APPLICATION NO.	FILING DATE	FIRST NAMED INVENTOR	ATTORNEY DOCKET NO.	CONFIRMATION NO.
10/787,438	02/27/2004	Tetsunori Kaji	648.42456VX2	4727

Office Action Summary

DETAILED ACTION

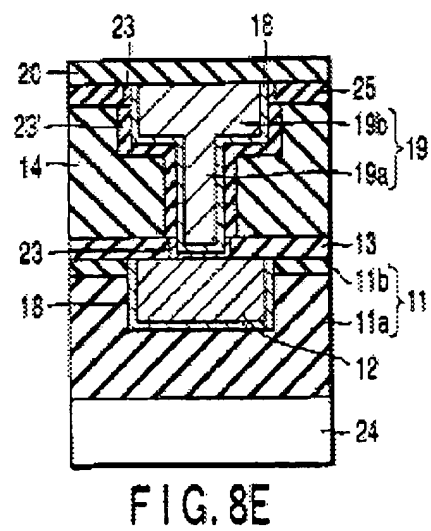
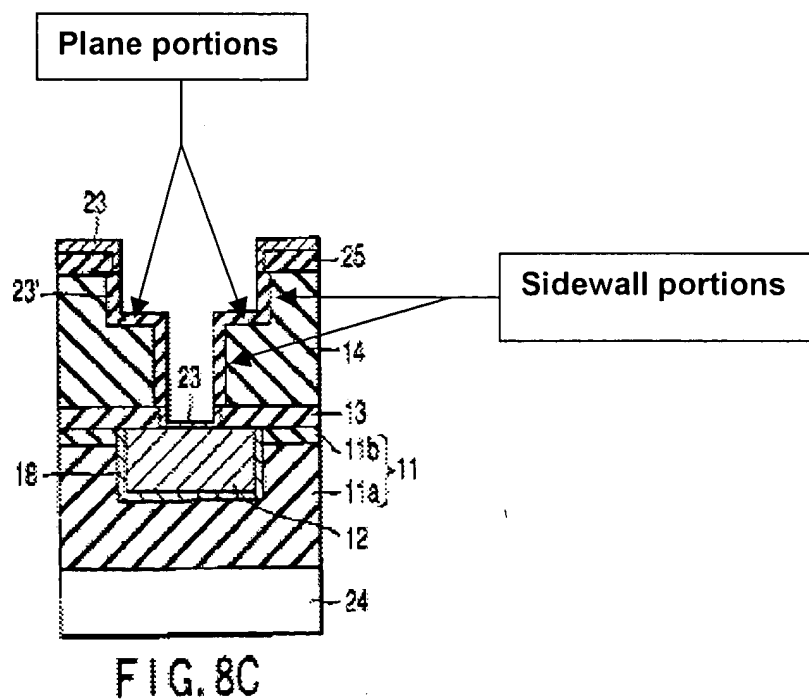
Regarding claim 1, Ito (Fig. 8E) discloses a conductive structure formed by filling copper 19 (paragraph [0060], the last 5 lines) in a plug portion 15/17 formed on an insulating film 14, the plug portion 15/17 having a metal oxide 23' (paragraph [0082]) functioning as copper barrier layer (paragraph [0084]) and formed by diffusing the metal into the insulating film 14 and reacting the metal with the insulating film 14 (paragraph [0082], lines 1-11) to reach a depth in a range of 3 nm to 50 nm (paragraph [0053] and paragraph [0077]) from the surface of side wall portions and plane portions (see Fig. 8C) defining an inner wall of the plug portion, and having copper 19 filled in the plug portion. It is noted that the conductive structure shown in Ito's Fig. 8E is a conductive damascene structure because it is formed by etching a via hole 15 and a trench 17 in an insulating layer 14 (see paragraph [0081]) (as defined by Applicant in Fig. 3 and Specification, page 19).

Regarding claim 2, Ito (Fig. 8E) discloses a conductive structure formed by filling copper 19 (paragraph [0060], the last 5 lines) in a plug portion 15/17 formed on an insulating film 14, the plug portion 15/17 having on its inner wall a two-step trench portion 15/17 comprising a large cross-section 17 and a small cross-section 15 (see Fig. 8B) via a plane portion, the plug portion 15/17 having a metal oxide 23' (paragraph [0082]) functioning as copper barrier layer (paragraph [0084]) and formed by diffusing the metal into the insulating film 14 and reacting the metal with the insulating film 14 (paragraph [0082], lines 1-11) to reach a depth in a range of 3 nm to 50 nm (paragraph [0053] and paragraph [0077]) from the surface of side wall portions and plane portions (see Fig. 8C) defining an inner wall of the plug portion, and having copper 19 filled in the plug portion. It is noted that the conductive structure shown in Ito's Fig. 8E is a conductive damascene structure because it is formed by etching a via hole 15 and a trench 17 in an insulating layer 14 (see paragraph [0081]) (as defined by Applicant in Fig. 3 and specification, page 19).

Ito (Fig. 8E) discloses a sample having a conductive structure formed thereto by filling copper 19 (paragraph [0060], the last 5 lines) in a plug portion 15/17 formed on an insulating film 14, the plug portion 15/17 having a width with a metal oxide 23' (paragraph [0082]) functioning as copper barrier layer (paragraph [0084]) and formed by diffusing the metal into the insulating film 14 and reacting the metal with the insulating film 14 (paragraph [0082], lines 1-11) to reach a depth in a range of 3 nm to 50 nm (in claim 3) or 5 nm to 30 nm (in claim 4) (paragraph [0053] and paragraph [0077]) from the surface of side wall portions and plane portions (see Fig. 8C) defining an inner wall of the plug portion, and having copper 19 filled in the plug portion provided with the barrier layer 23'. It is note that the conductive structure shown in Ito's Fig. 8E is a conductive damascene structure because it is formed by etching a via hole 15 and a trench 17 in an insulating layer 14 (see paragraph [0081]) (as defined by Applicant in Fig. 3 and specification, page 19).
